ADA Curb Ramp New Construction Inspection Form (Parallel)

NW Timeric

23885.56

NW Belgium

PARALLEL RAMP (PL)

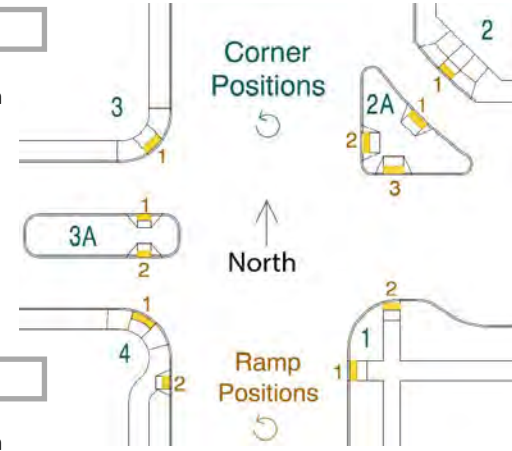
$\leq 1/4"$ ☐ $> 1/4"$ ☒

2.1 $\leq *$ ☐ $> *$ ☒

☐ 9.72 $\leq 8.3\%$ ☐ $> 8.3\%$ ☒

9.3 $\leq 2.0\%$ ☐ $> 2.0\%$ ☒

11.2 $\leq 2.0\%$ ☐ $> 2.0\%$ ☒

Comments:

NTD RR1 TS Fail
